## Site Design Review (Type III) SDR-20-01

### STAFF REPORT

**Subject:** Site Design Review for Dollar General Store

**Location:** 700 W. Main Street John Day, OR  
Map: 13S31E22D Tax Lot(s): 305 (Parcel 2)

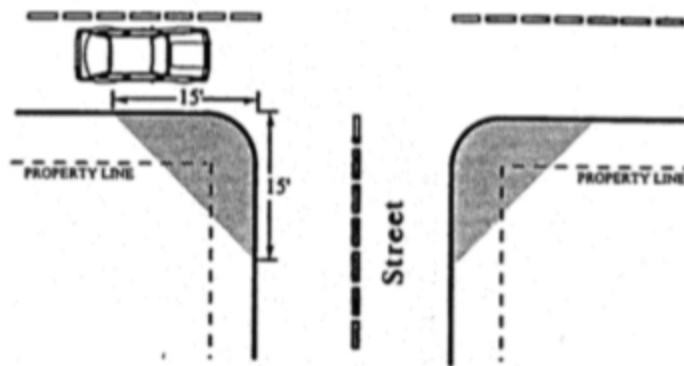
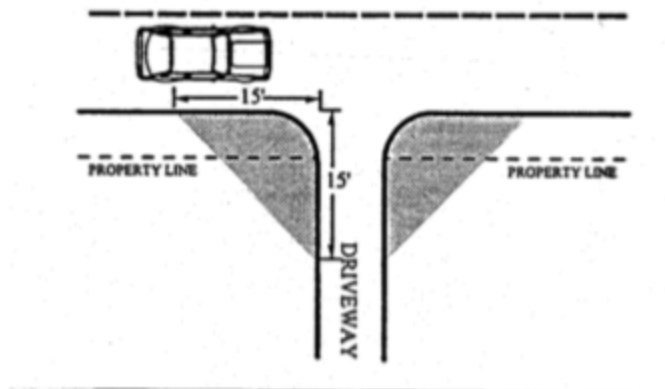
- **Fire Access and Turnarounds:** *Driveway width proposed is 36 feet and site circulation was designed to accommodate a WB-67 truck as well as fire and garbage trucks.*
- **Vertical Clearances:** *This proposal meets the vertical clearance requirement of 13' 6" for the entire length and width.*
- **Vision Clearances:** *No visual obstruction (e.g., sign, structure, solid fence, or shrub vegetation) between three (3) feet and eight (8) feet in height will be placed in "vision clearance*

areas” at street intersections on streets, driveways, alleys, or mid-block lanes. There is an existing utility pole located about 16 feet east of the proposed driveway, however it should not interfere with the vision clearance triangles.
